IN THE DRAWINGS:

REMARKS

Applicant appreciates the time taken by the Examiner to review Applicant's present application. This application has been carefully reviewed in light of the Official Action mailed March 24, 2004. Applicant respectfully requests reconsideration and favorable action in this case.

Fig. 5

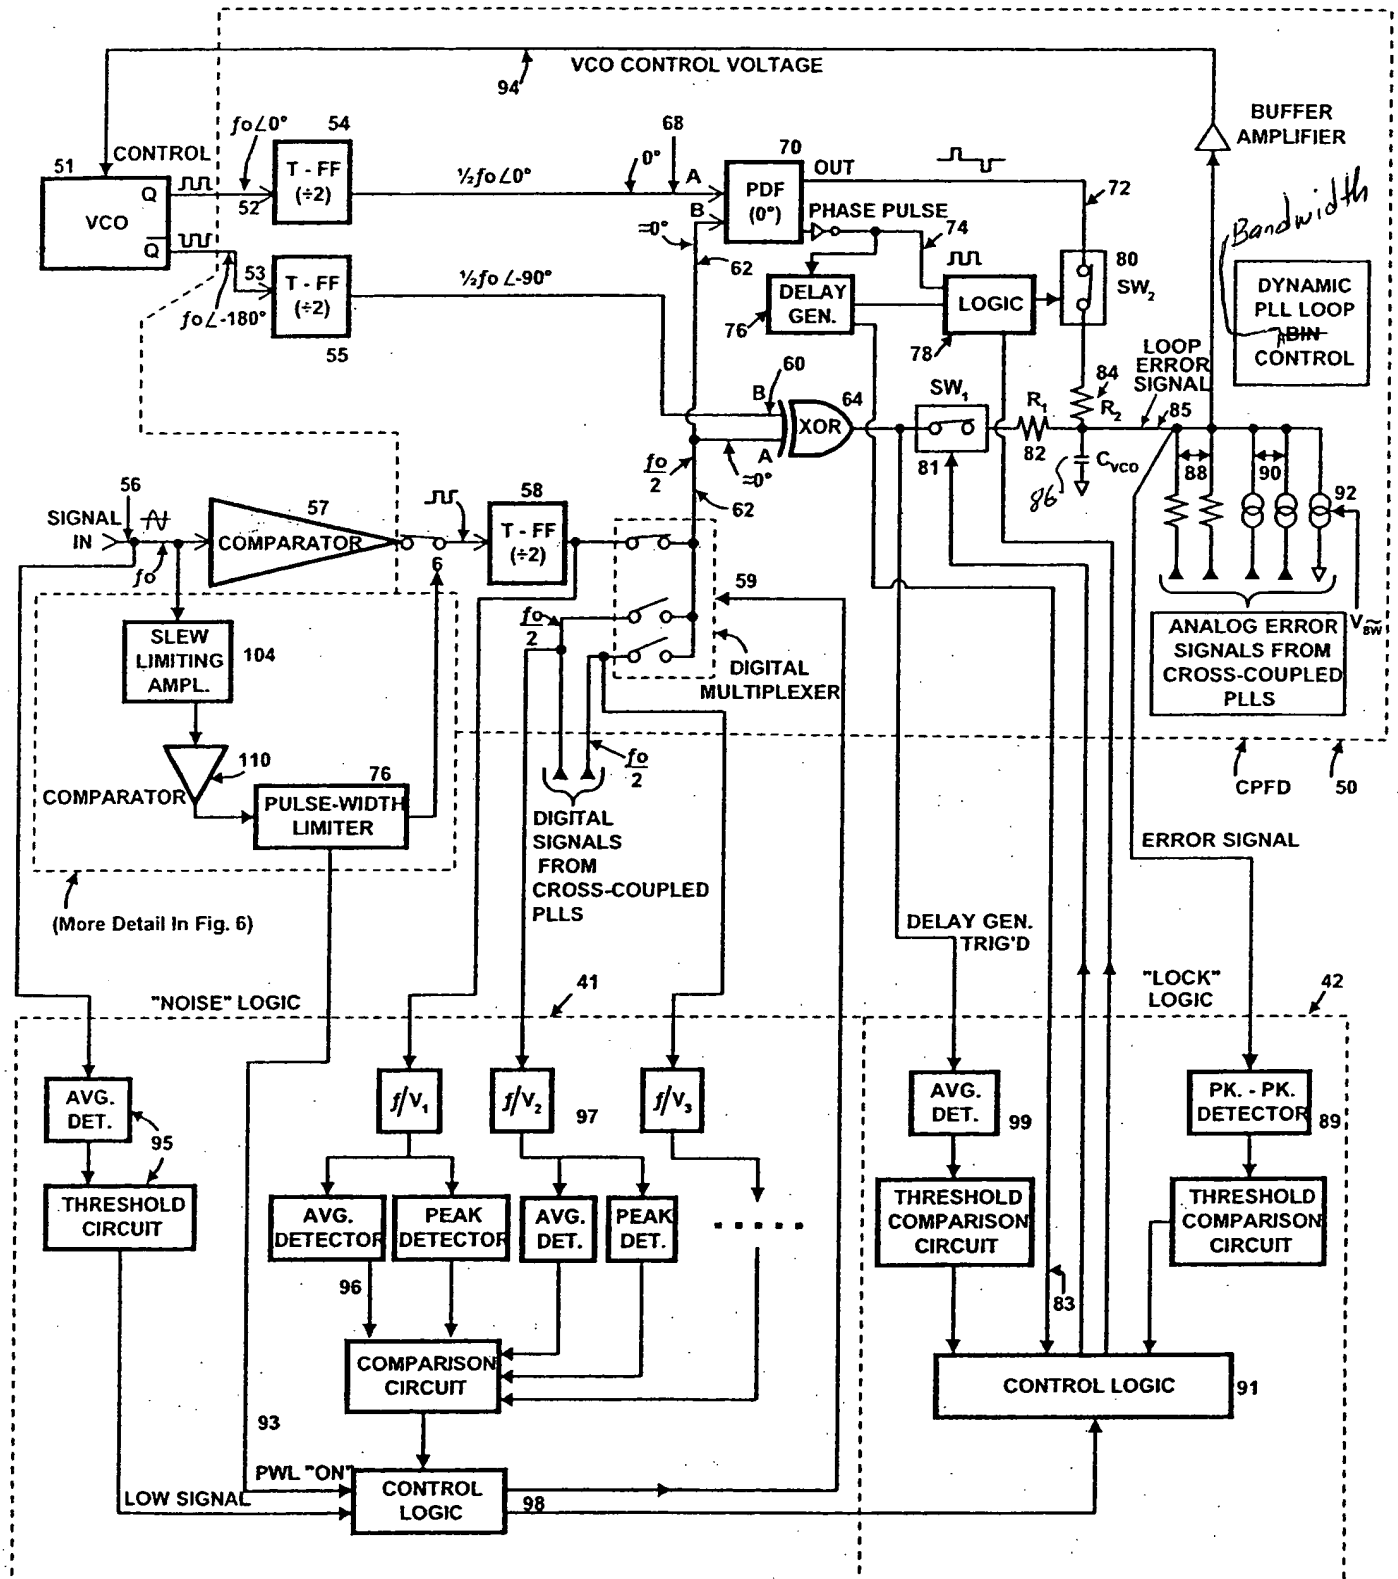
Applicant submits herewith one copy of eight sheet(s) of replacement drawings. Applicant requests that the Examiner approve the substitute drawings. Marked-up versions of the substitute sheet(s) of drawings are attached hereto with the change(s) shown with red ink markings. Support for the depiction of detail number 86 in figure 5 is found at line 10 of page 22 of this application as originally filed.
